Agenda Report

TO: Honorable Mayor and City Council
FROM: Planning & Community Development Department
SUBJECT: **PREDEVELOPMENT PLAN REVIEW OF A MIXED-USE
DEVELOPMENT PROPOSED AT 150 E. COLORADO BOULEVARD**

Figure 3: Proposed Setbacks

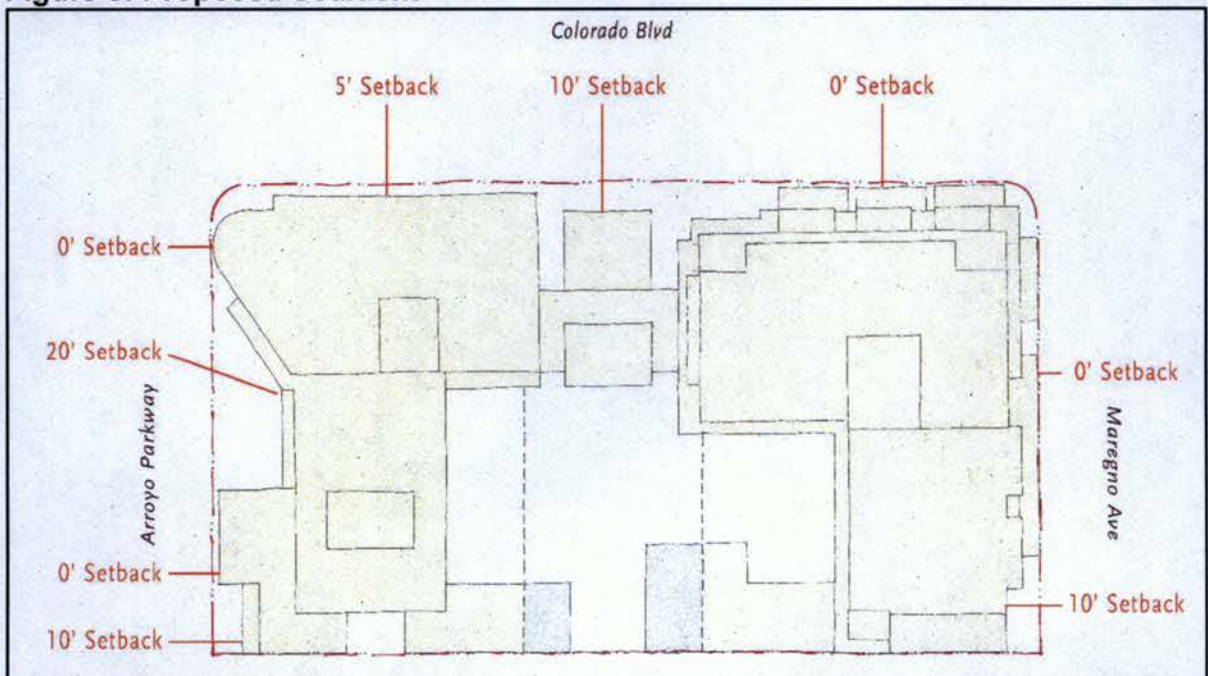
| Arroyo Parkway: Build to property line | 0' to 20' |
| Colorado Boulevard: Build to property line | 0' to 10'+ |
| Marengo Avenue: Build to property line | 0' to 10' |

Figure 4: Proposed Building Heights (in stories)

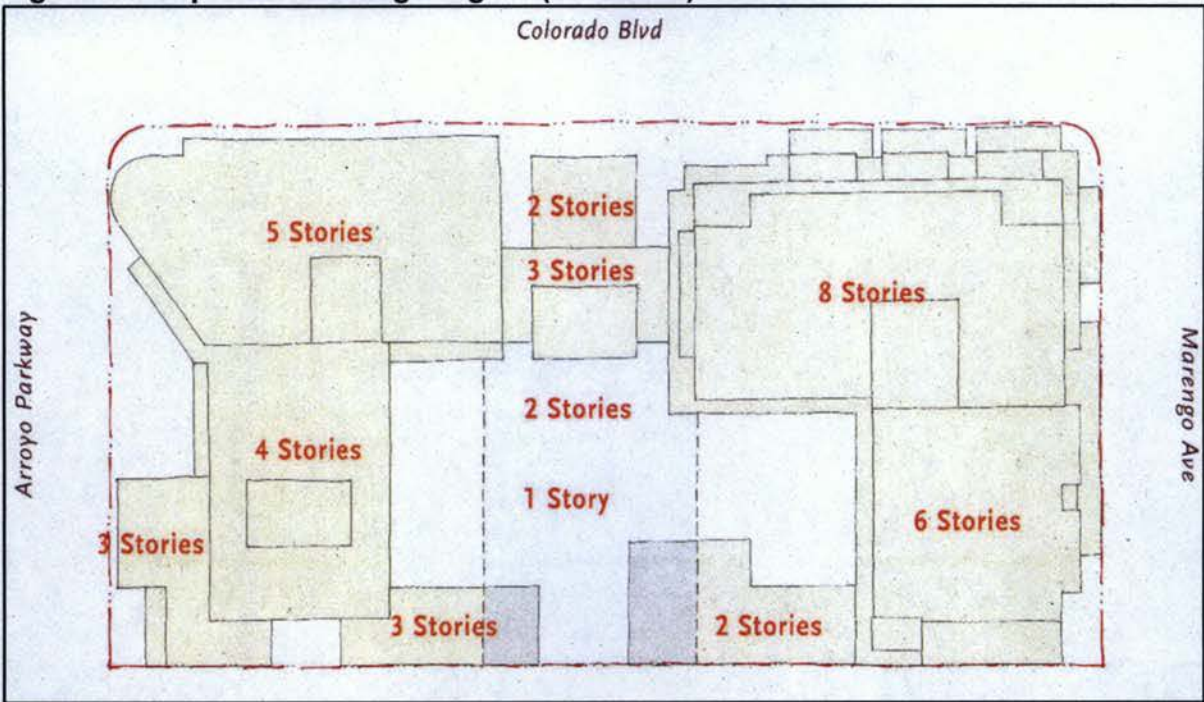
The maximum building height is 75 feet but may be increased up to 90 feet using height averaging. Height averaging requires Design Commission approval and findings to be made. While the project design varies height across the site (2 to 8 stories along street frontages), the project proposes a maximum building height of approximately 117 feet, exceeding the maximum allowed. The applicant is not proposing height averaging. The steep topography of the site and the City's method for measuring building height contribute to the resulting 117-foot figure for height. The maximum height of a structure is measured from the lowest elevation of the existing grade at an exterior wall of the structure to the highest point of the structure. The applicant's proposal to locate taller portions of the project at higher elevations as opposed to lower elevations also contributes to the resulting figure for height. However, as noted by Community Planning staff, the proposal reflects the existing variation of heights in the vicinity. Adjacent buildings to the north across Colorado Boulevard and east across Marengo Avenue are comparable in scale with seven or more stories. Adjacent properties across Arroyo Parkway generally consist of fewer stories (six or less). A five level parking garage is located to the south.

The proposal exceeds the maximum allowed building height. The maximum allowed building height is 75 feet, where the applicant's proposal is approximately 117 feet tall. The 75-foot limit may be exceeded (up to a maximum of 90 feet) through a process called height averaging. The applicant's proposal does not include height averaging. The applicant is required to modify the project design to comply with the allowed building height, modify the project and receive approval from the Design Commission for height averaging, or pursue a Variance application. This application is reviewed by a Hearing Officer.
